SITE SUPPLEMENTAL INSTRUCTION

PROJECT: Forestside Estates
Attmar & Palleschi Drive
Brampton, ON

SITE SI NO. M-4

PURPOSE: To revise mechanical layout to suit Arch change and reply city plumbing comments.

DRAWN	CHECKED	SCALE
MC	LM	1:100
DATE	PROJECT	DRAWING
MAY, 2019	18-017	M-4A
		OF -

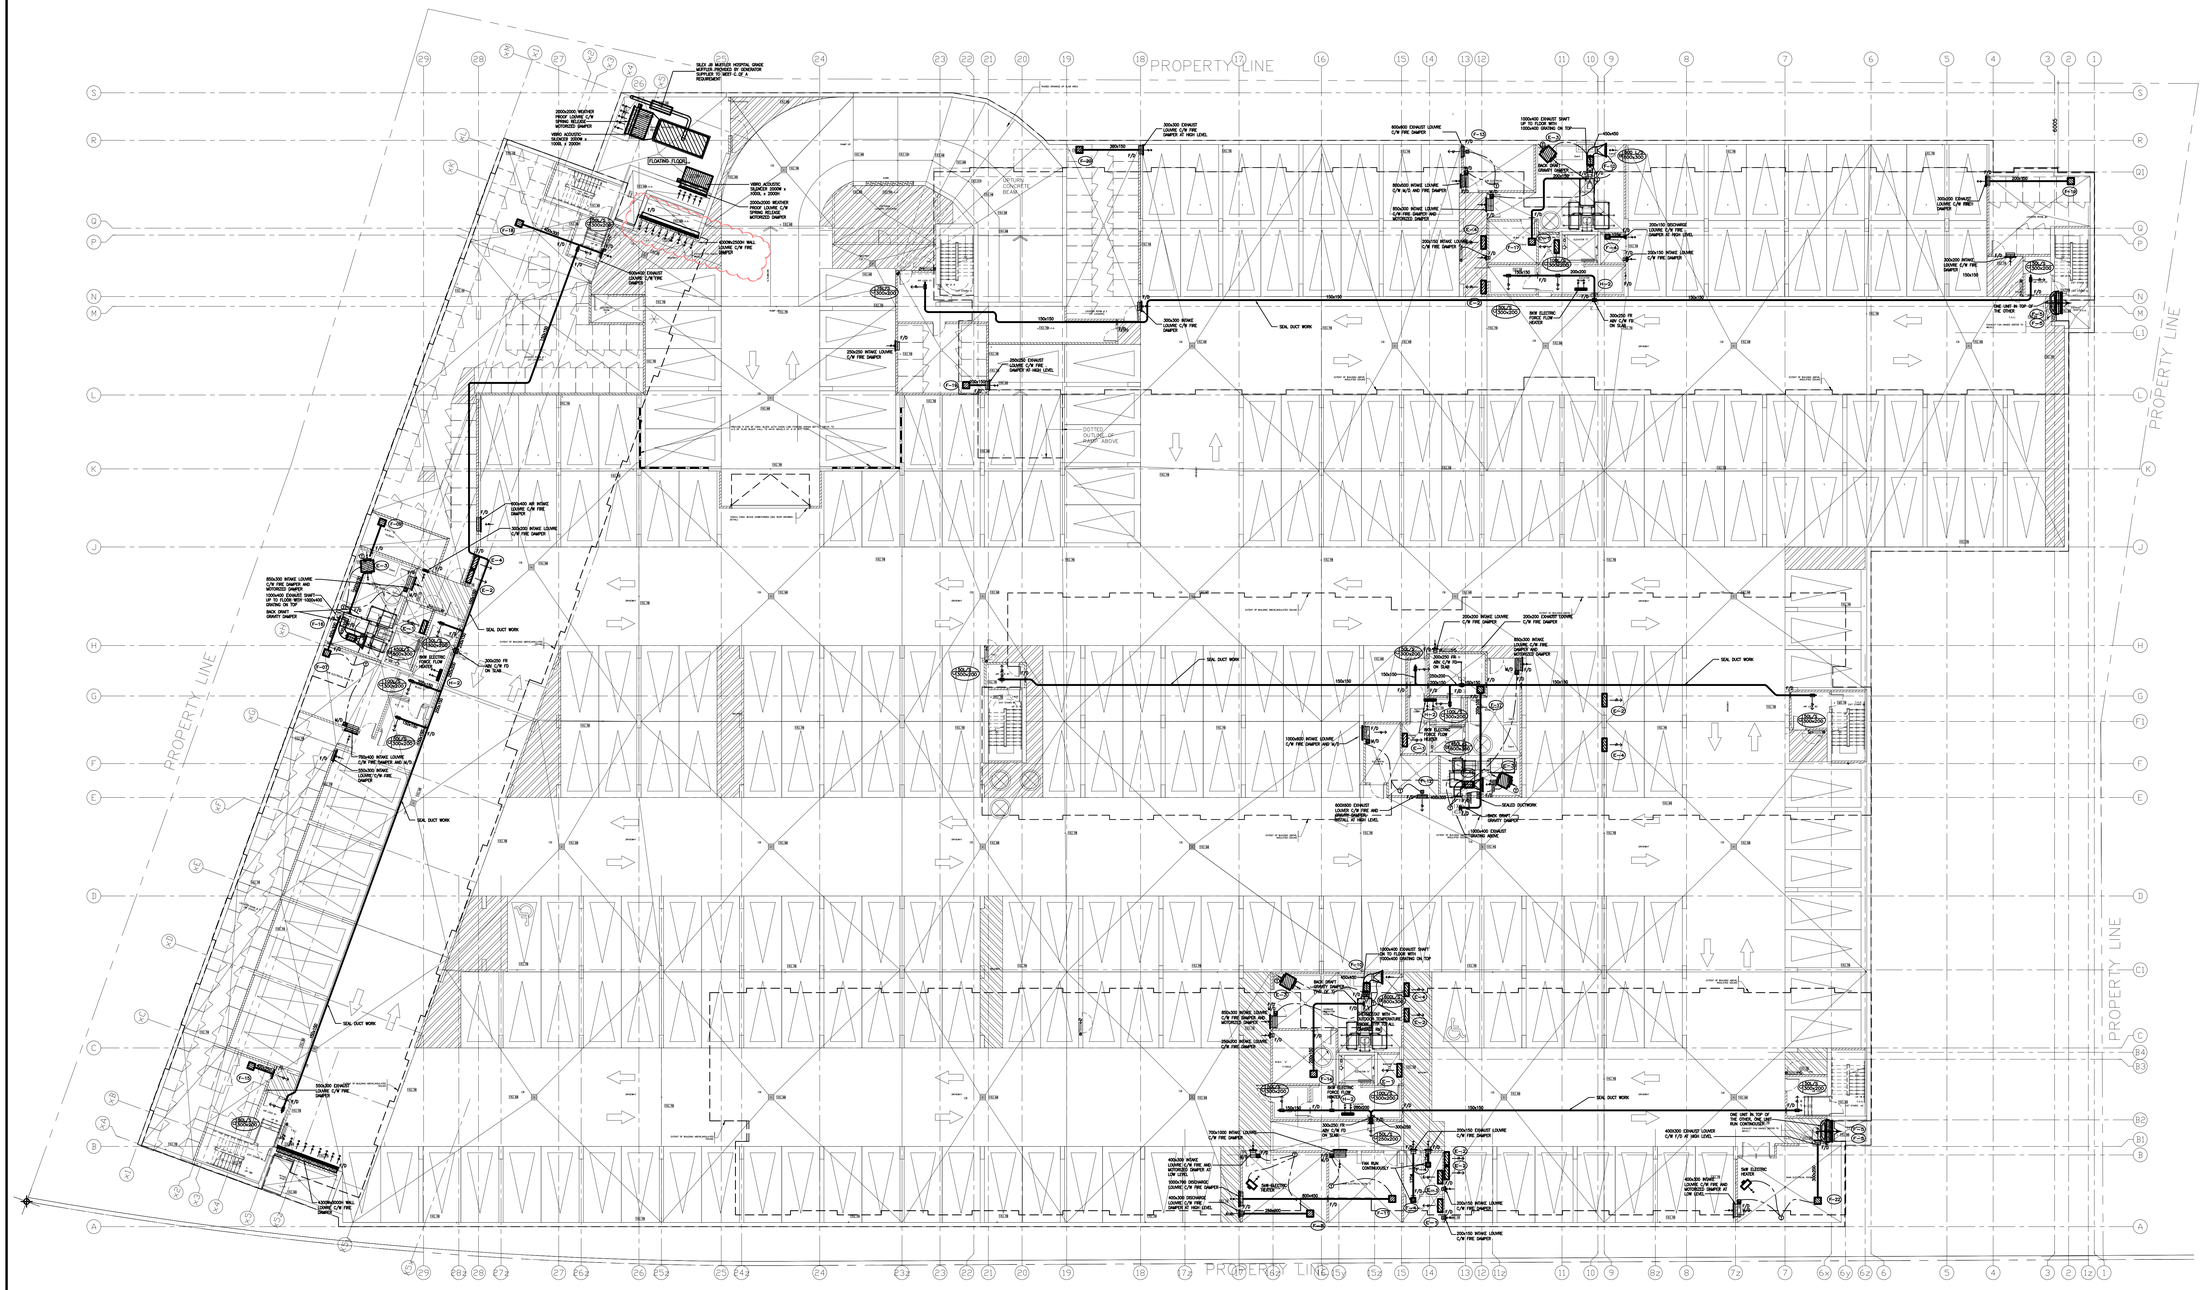
1.0 Reference Drawing M-4, M-4A (HVAC P1 - Mechanical) Issued

1.1 Revised: Intake louver size to suit Arch change.

DRAWN	CHECKED	SCALE
MC	LM	1:50
DATE	PROJECT	DRAWING
MAY, 2019	18-017	M-10
		OF -

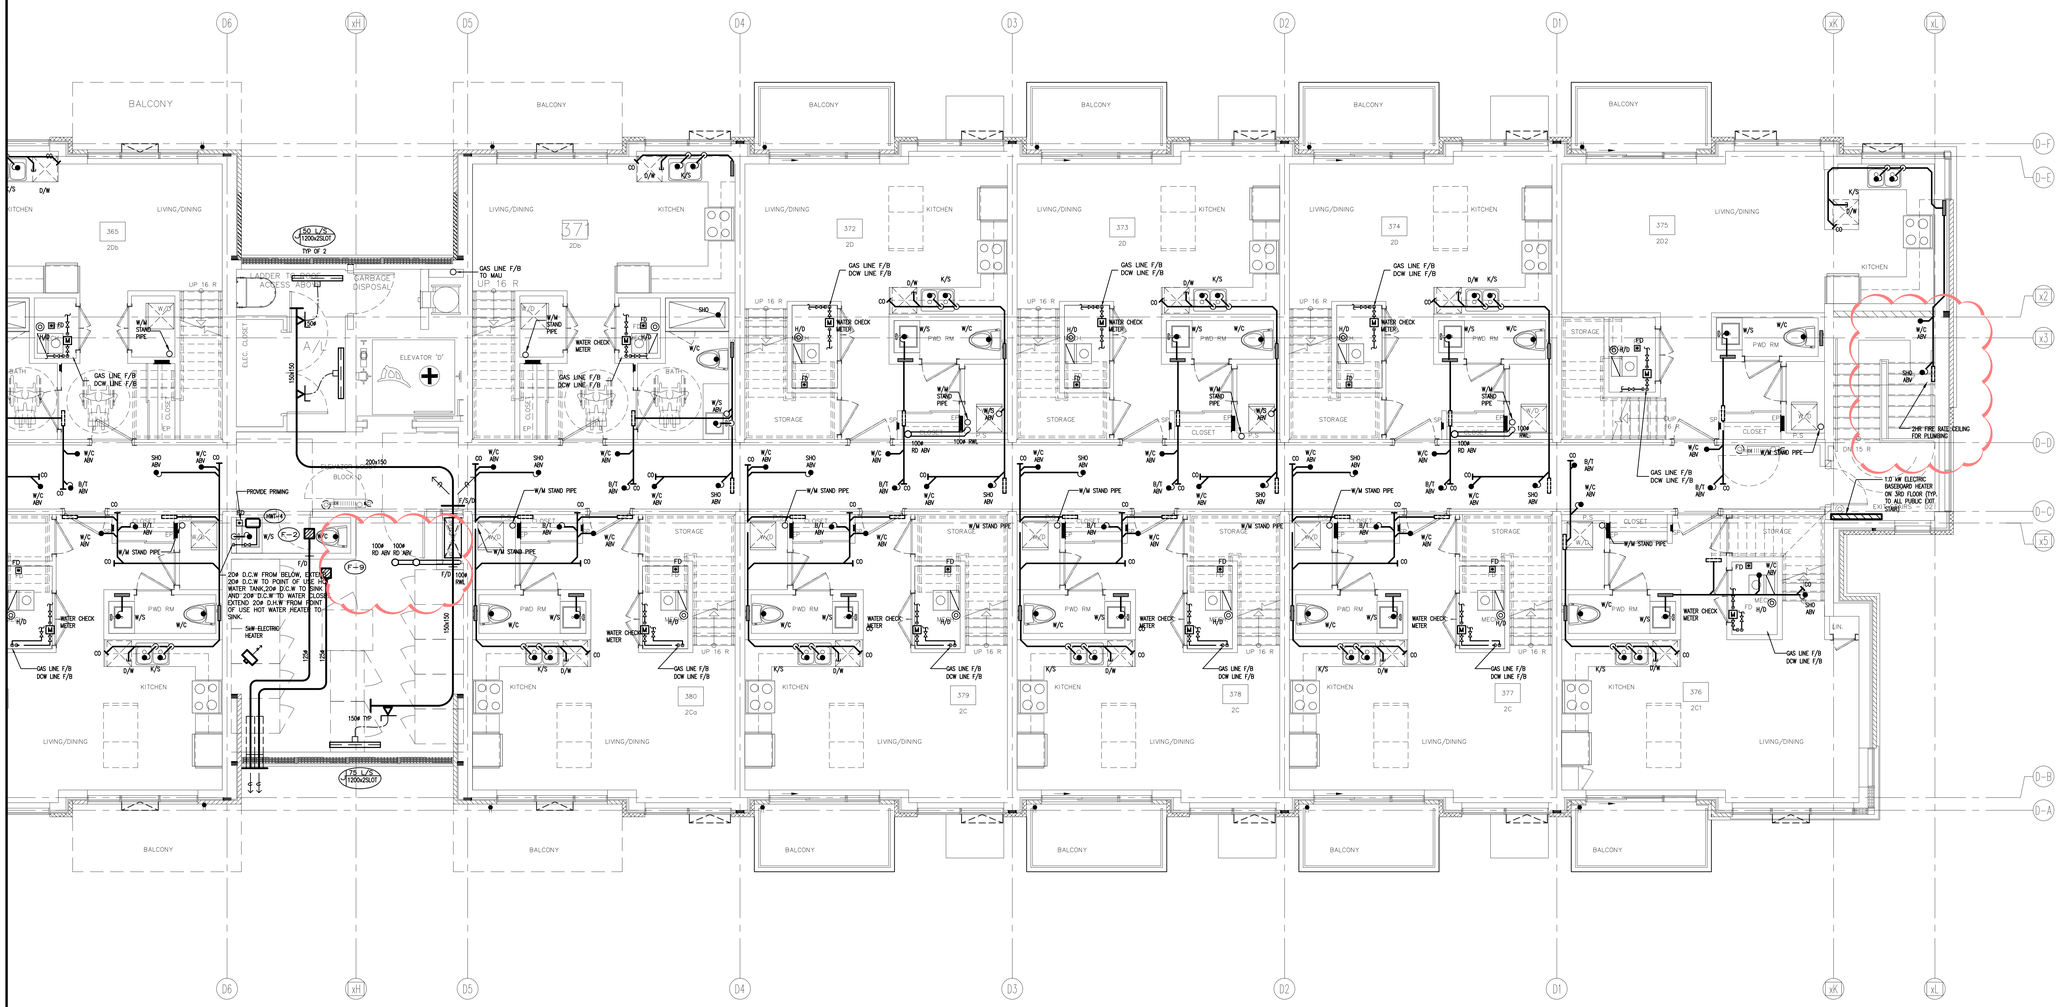
2.0 Reference Drawing M-7-M-14 (Building D - Mechanical) Issued

2.1 Showed: Kitchen dishwasher and clean out for suite type 1C, 1A, 1Aa, 1Ba.

2.2 Added: 2 hour fire rate ceiling for plumbing at 3rd floor stair.

2.3 Added: Roof drain for 3rd floor roof and picked up below.

2.4 Clarify: Location and numbers of scupper drains at roof.

DRAWN	CHECKED	SCALE
MC	LM	1:50
DATE	PROJECT	DRAWING
MAY, 2019	18-017	M-21
		OF -

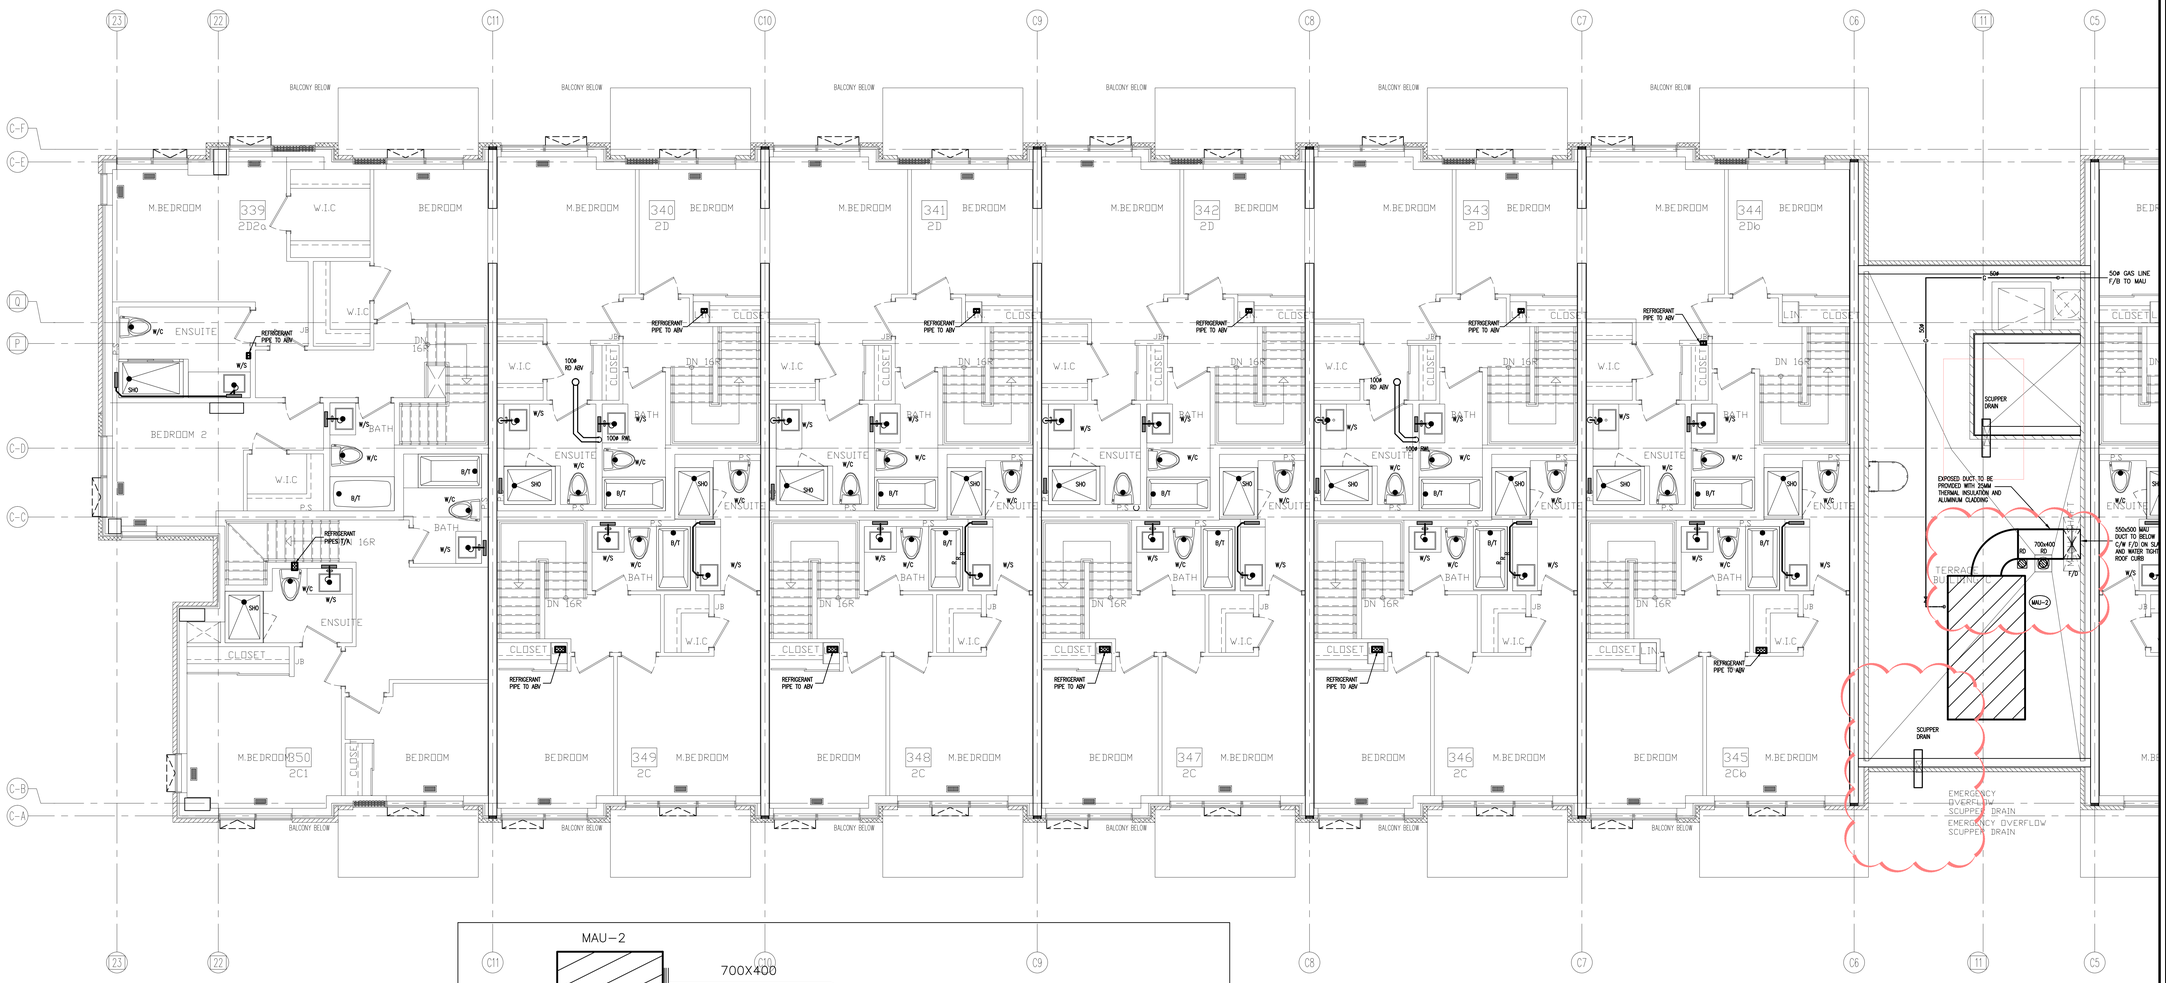
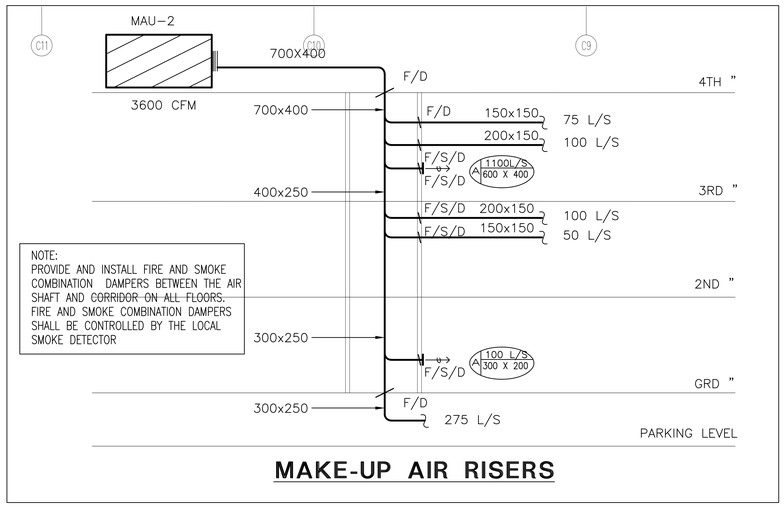
3.0 Reference Drawing M-15, M-19-M-24 (Building C - Mechanical) Issued

3.1 Added: Eight 1KW electrical heater for drive way ceiling, one 5 KW electrical heater for service room.

3.2 Added: 2 hour fire rate ceiling for plumbing at 3rd floor stair.

3.3 Added: Roof drain for 3rd floor roof and picked up below.

3.4 Clarify: Location and numbers of scupper drains at roof.

3.5 Relocated: Sanitary piping and domestic cold water and gas line to inside pipe space.

3.6 Revised: Suite# 241,242,243,252,253,254 gas and DCW line location.

3.7 Revised: Suite# 341,342,343,352,353,354 Mechanical room layout.

DRAWN	CHECKED	SCALE
MC	LM	1:50
DATE	PROJECT	DRAWING
MAY, 2019	18-017	M-25
		OF -

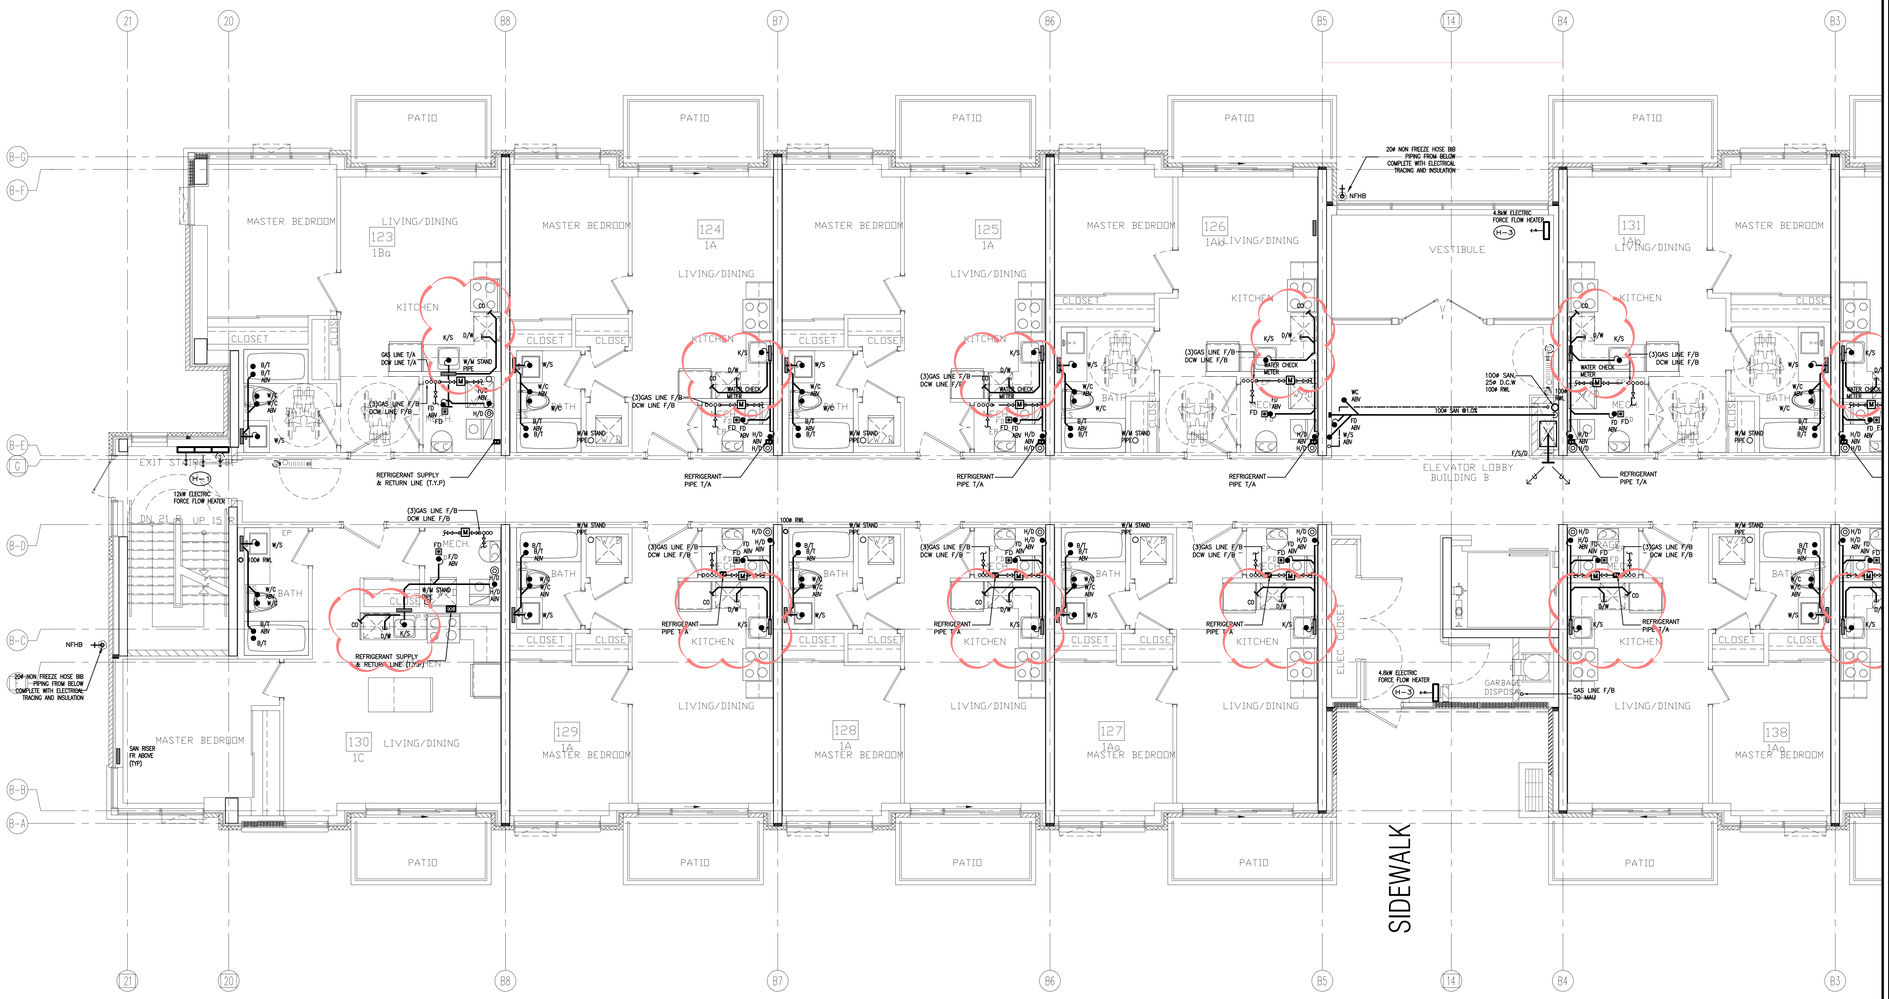
4.0 Reference Drawing M-25-M-34 (Building B - Mechanical) Issued

4.1 Showed: Kitchen dishwasher and clean out for suite type 1C, 1A, 1Aa, 1Ab, 1Ba.

4.2 Added: 2 hour fire rate ceiling for plumbing at 3rd floor stair.

4.3 Added: Roof drain for 3rd floor roof and picked up below.

4.4 Clarify: Location and numbers of scupper drains at roof.

4.5 Revised: Suite# 228,229,236,237 gas and DCW line location.

4.6 Revised: Suite# 328,329,336,337 Mechanical room layout.
